AGENDA CITY OF THE DALLES PLANNING COMMISSION THURSDAY, JUNE 18, 2020 6:00 P.M.

Appeal 030-20 of SUB 74-19, Robert Bokum, Denise Dietrich-Bokum, Gary Gingrich, Terri Jo Jester Gingrich, and Damon Hult -- **Public Hearing continued from May 21, 2020.**

REQUEST: Appeal of the administrative approval on March 9, 2020, of Subdivision 74-19, Legacy Development Group, to divide one 6.92 acre parcel into 72 lots of varying size with a proposed community park.

Resolution 593-20: Denial of APL 030-20 and affirming approval of SUB 74-19

Subdivision - Plat Proposal
Scale: 1:30

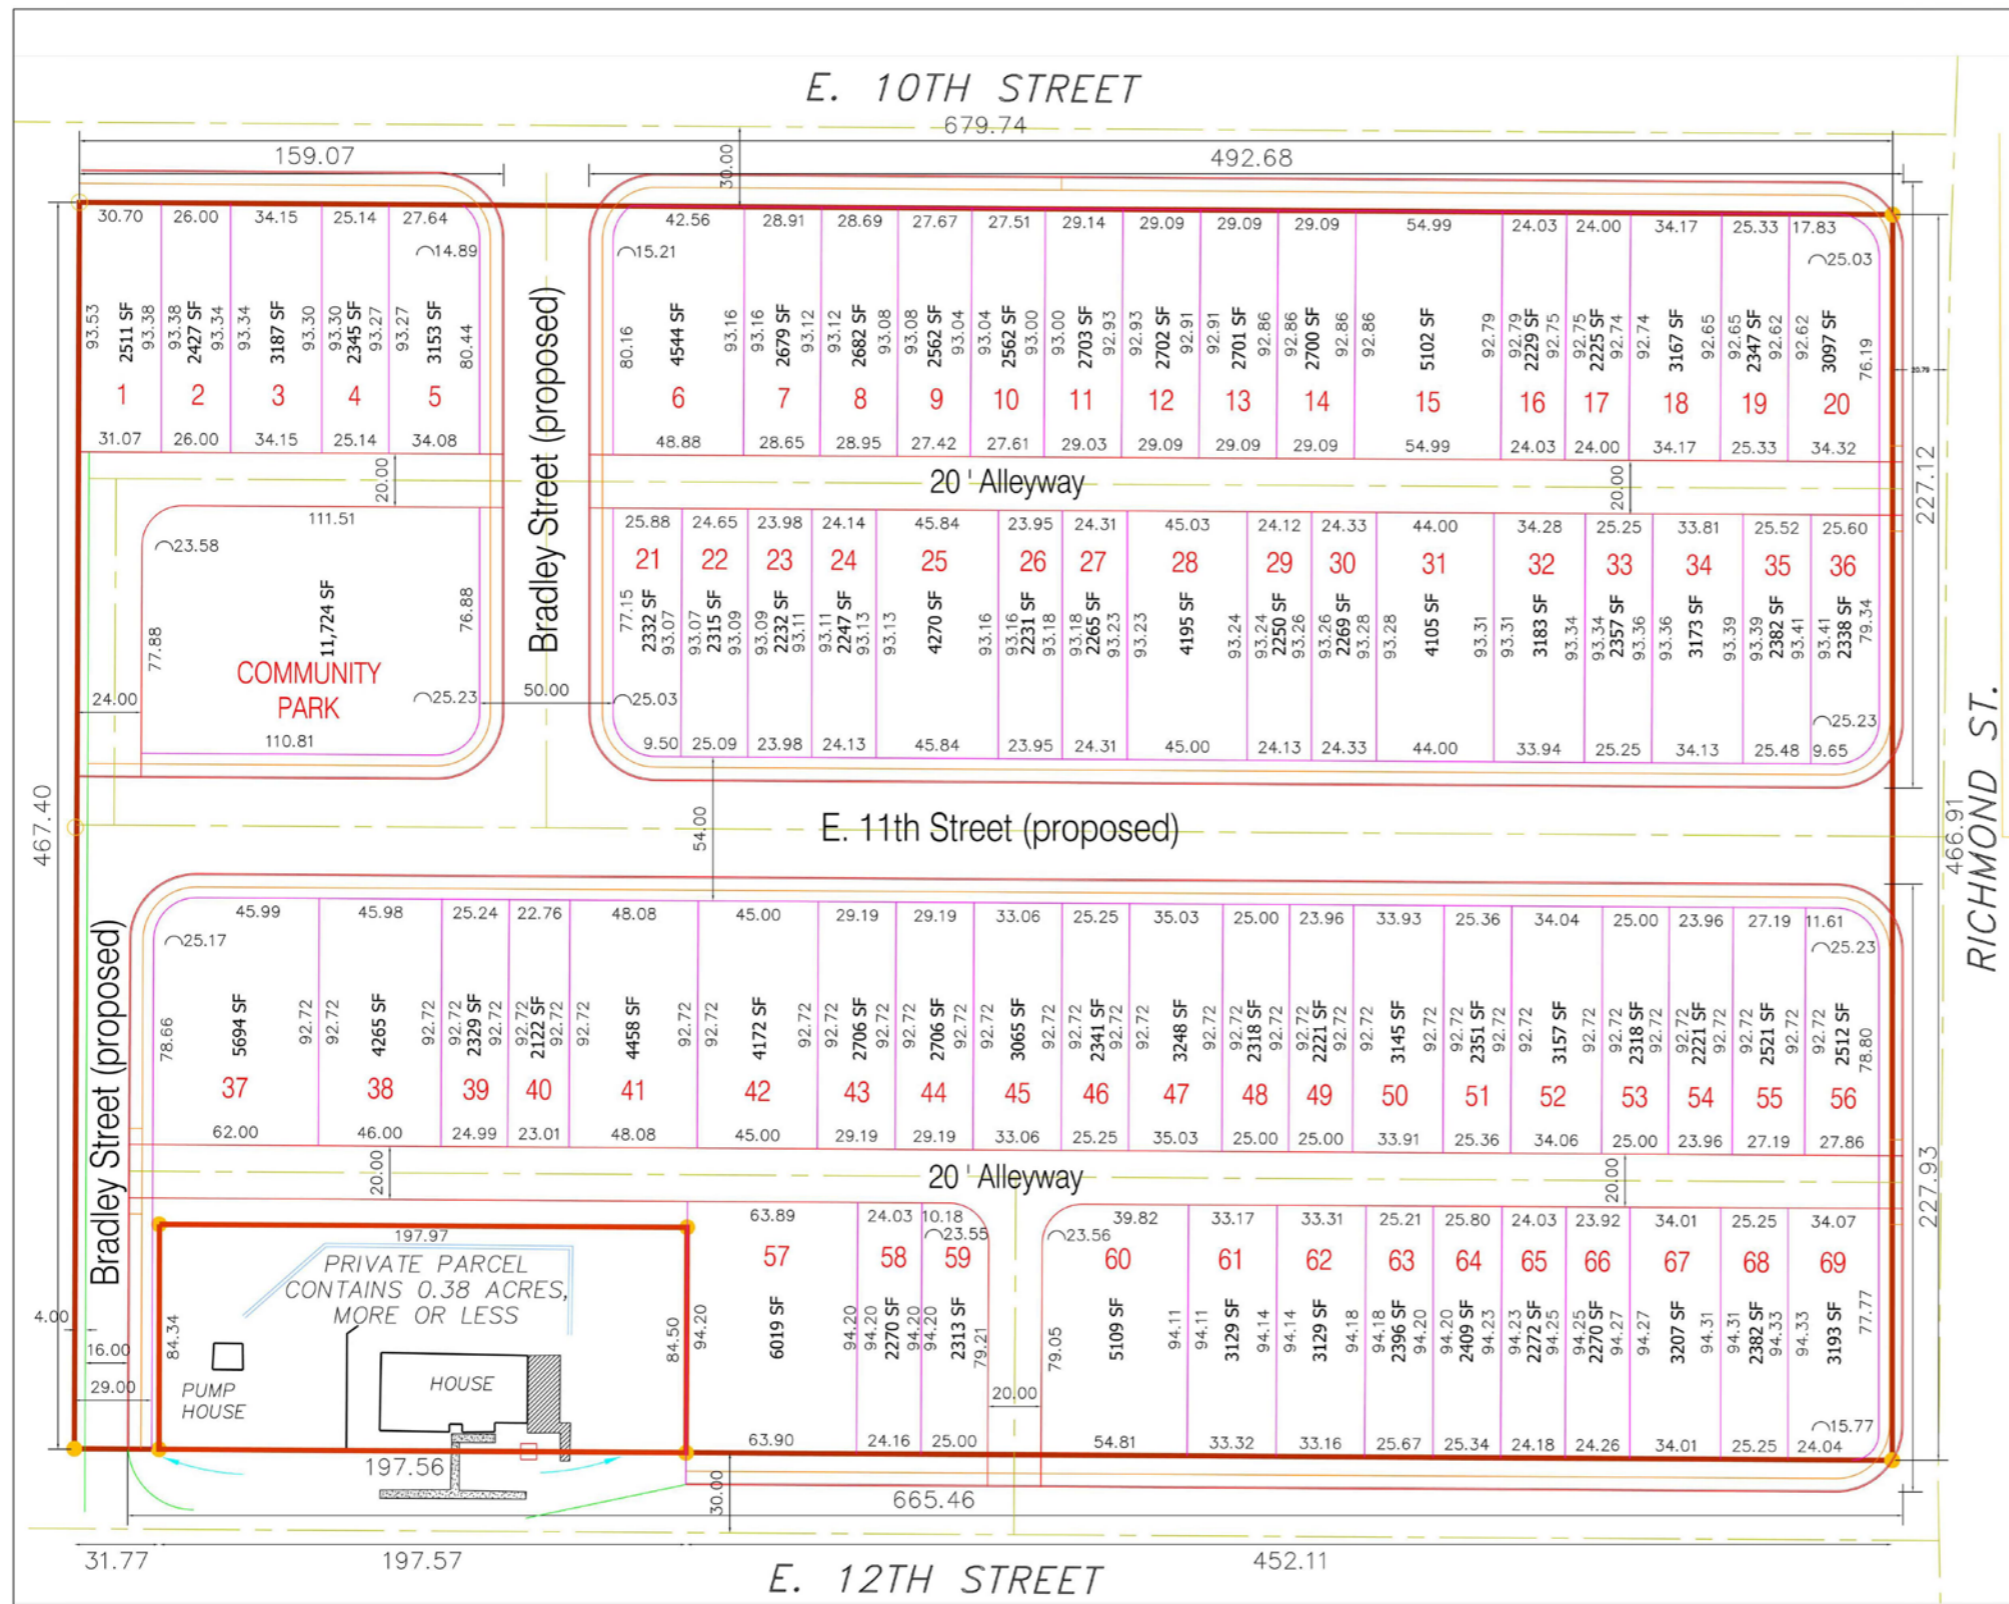
In order to approve the application, the applicant would need to submit plans showing that there is room on each lot to accommodate building envelopes for all proposed buildings, while meeting all setbacks and providing all required driveways, on-site parking landscaping. The burden is on the applicant to demonstrate that all criteria are met. How can the applicant demonstrate how all these standards can be met for each lot without submitting plans showing how each lot can provide for all proposed buildings, setbacks, required driveways and parking, while also providing the required landscaping and meeting the 60% lot coverage standard?

No such plans have been submitted. This is a serious defect, requiring denial of the application on this record. Absent plans showing how these code provisions can be met, the application cannot be approved. Under the relevant LUBA caselaw cited at the beginning of this letter, compliance with these standards cannot be deferred into the conditions without substantial evidence that the standards can be met and findings that the conditions are “reasonably certain to succeed.”

Response to Appellants’ Rebuttal - Argument #3, June 11, 2020: The Appellants’ Argument #3 suggests that individual site plans be submitted for each of the residential dwelling parcels, to ensure that all requirements of Section 10.5.020.060 are met. As clarification, Staff is not approving building placement of each individual lot at this time. The City will require that each of the parcels be reviewed individually through a ministerial application process reviewed by both the CDD and Public Works to ensure that the proposal complies with the requirements of TDMC. Review of each parcel to include but not limited to: landscaping, lot coverage, setbacks, parking, drive approaches and sidewalks, and available utilities. In addition, structural review of all future dwellings will be administered by Wasco County Building Codes to ensure that each parcel complies with Oregon Residential Specialty Code.

Since the May 21, 2020, Planning Commission meeting, the Applicant has provided a revised site plan and “Neighborhood Layout” plan, with scale bar, dimensions of parcels, ROWs, alleys, and building setbacks lines.

Response to Appellants’ Rebuttal - Argument #5, June 11, 2020: Since the initial approval of SUB 74-19, the proposed northern section of Bradley Street has been relocated, resulting in a full-street dedication rather than the half-street dedication originally proposed. This not only addressed safety concerns with a “blind hill” on E. 10th Street, but it also resolved Condition of Approval #6 which states: “The Applicant will be required to modify the overall subdivision layout to comply with the maximum block width standards (600 ft.) of Section 10.9.020.020 (C)...” as the block length between Bradley and Richmond Streets (north) has been reduced to 492.68’, originally 679.76’.

Although the relocation of Bradley Street has decreased the overall length of the newly proposed blocks within the subdivision, continuous street frontages with breaks (either street or alley) still exist with dimensions of ~663’ (E. 11th St, Lot #s 37-56) and ~493’ (E. 10th Street, Lot #s 6-20 and E. 11th Street Lots #s 21-36). Section 10.9.020.010, C, 2, a, requires that local streets and minor collectors must provide a permanent pedestrian/bicycle through pathway, established by ROW and at least 10 feet wide, near the middle of the blocks to provide a connection to the adjoining street on blocks greater than 450’. Staff will include as a condition of approval that a pedestrian path, no less than 10’ in width, be established through the northern block (bounded by E. 10th, 11th, Bradley, and Richmond Streets) and the southern block (bounded by E. 11th, 12th, Bradley, and Richmond Streets) to improve pedestrian connectivity within and through the development.
